**Waterbury Filing No. 1 & 2**  
**Operations and Maintenance Manual**  
**Extended Detention Basin**  
County Job No. PUDSP-21-005

## **GRADING AND EROSION CONTROL PLAN CHECKLIST PUDSP-21-005**

**Site: Waterbury Filings 1& 2**

HEC-RAS Plan: 1 River: pr east Reach: chan-east Profile: PF 1

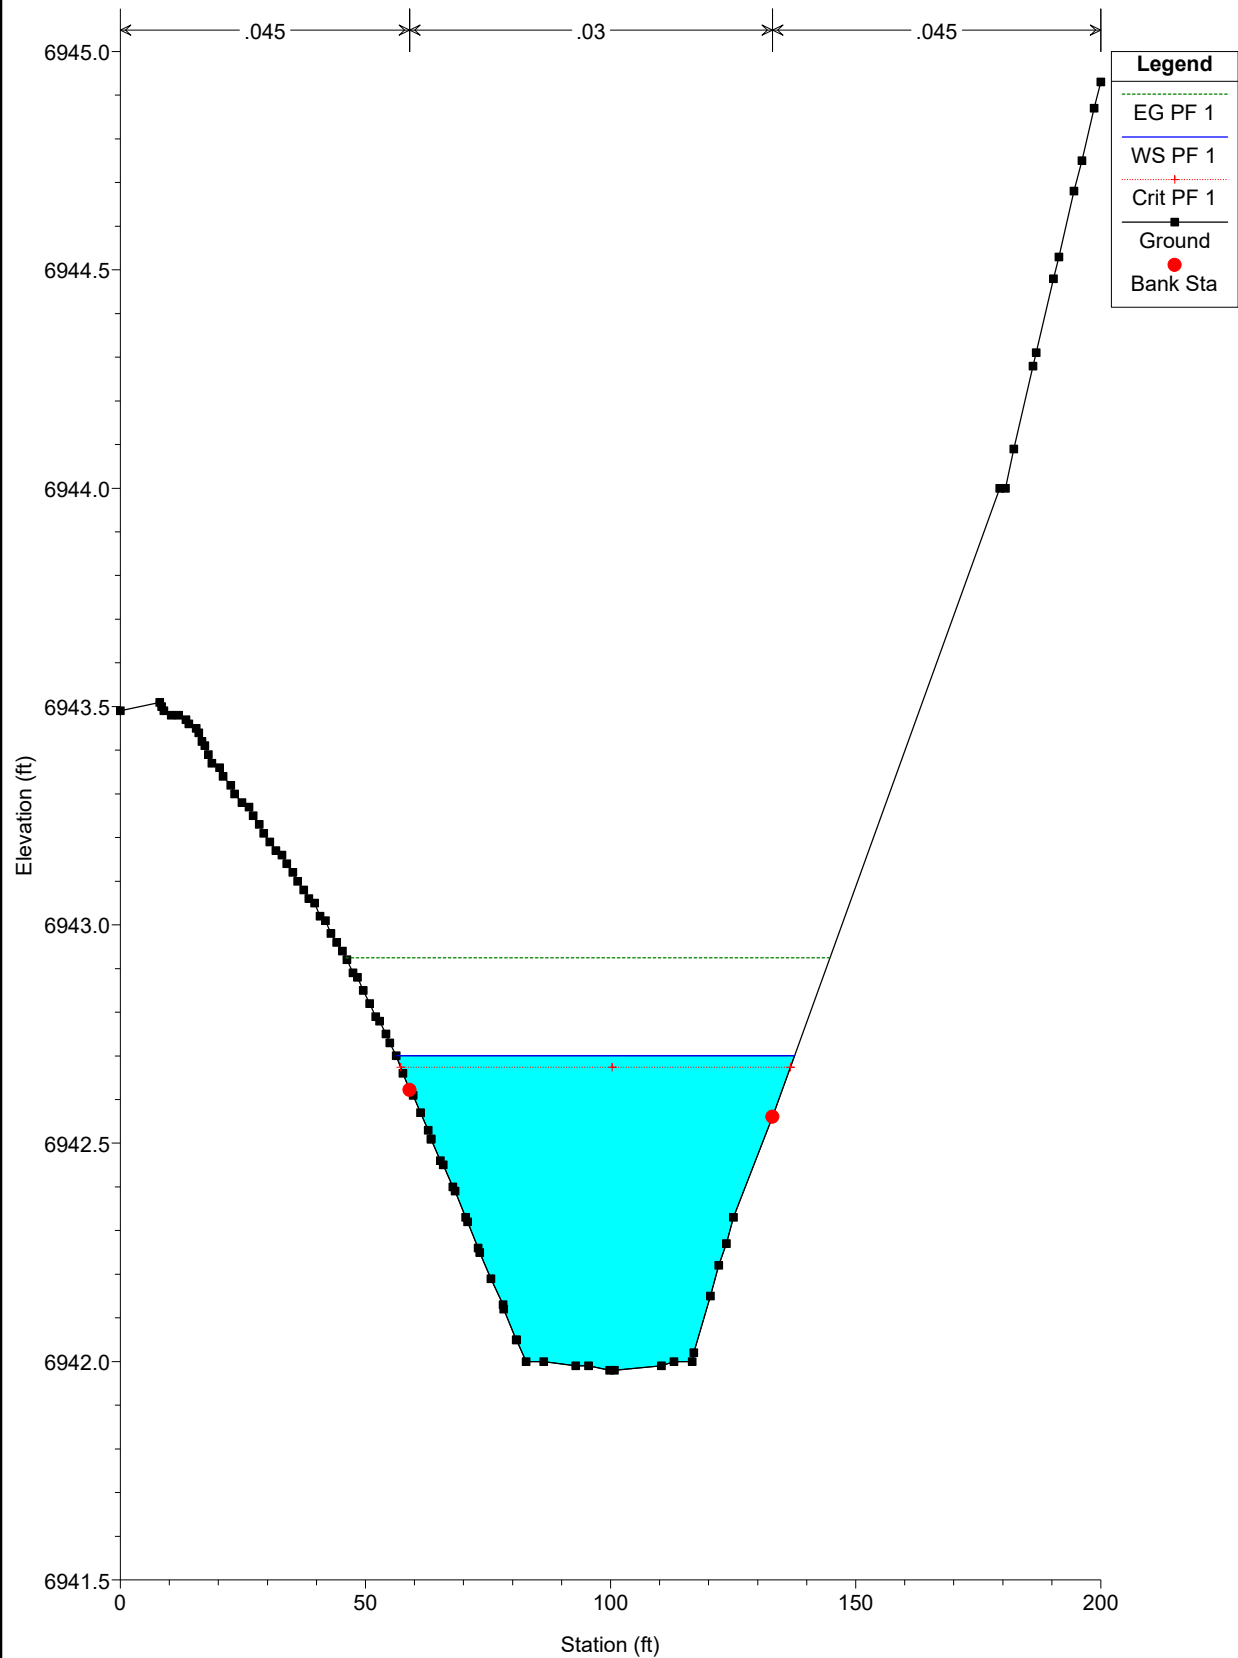
verify
